CONSTRUCTION STORMWATER GENERAL PERMIT INSPECTION REPORT

State of Washington Department of Ecology

The purpose of this inspection is to follow up with a site visit/inspection based on an Environmental Report Tracking System (ERTS) complaint (ERTS #699710) and to provide technical assistance as appropriate. On 3 August 2020, Ecology learned of the ERTS for the use of the sports turf (and small rubber bits that have degraded off the turf) in the river. Carol called the permittee, Thom Fischer to discuss the ERTS reported by a member of the public and the violation of CSWGP condition S5.F. Noncompliance Notification (permittee is obligated to self report). Thom explained he had used geotextile fabric below the 80 ml liner but was unable to prevent ripping of the liner, so he used the sports turf below the liner. Rolls of sports turf were delivered from a nearby rock quarry. The rolls were delivered to the site (at the staging area along the bend in the haul road to the in-water construction zone area), then a crane was used to place the rolls of sports turf in the riverbed. The crane is on the left bank of the Puyallup River. The river is now flowing in the lined portion of the chan

Photo 3

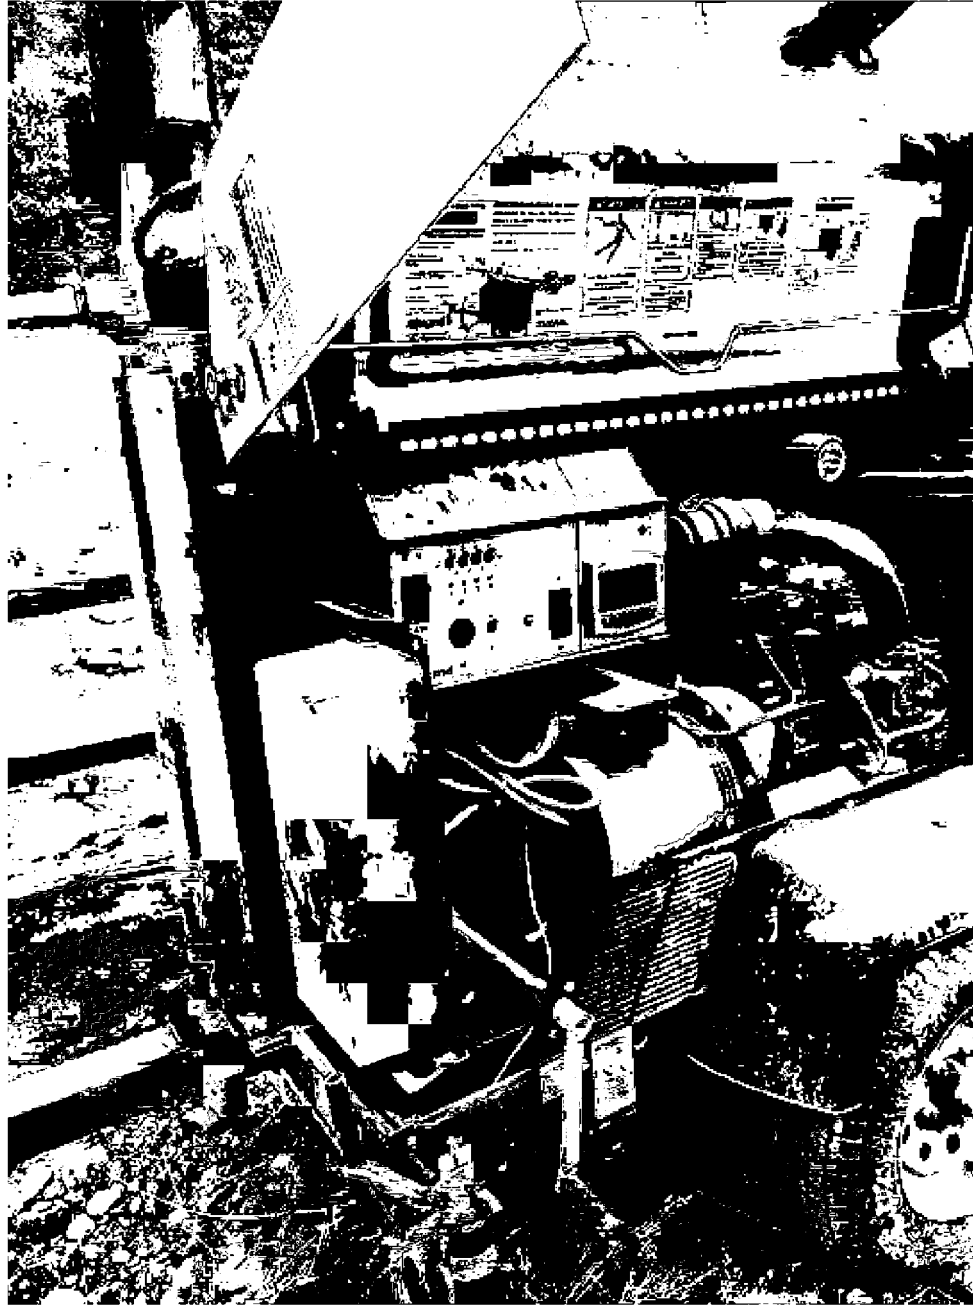
Photo Description: Light pole generator with secondary containment.
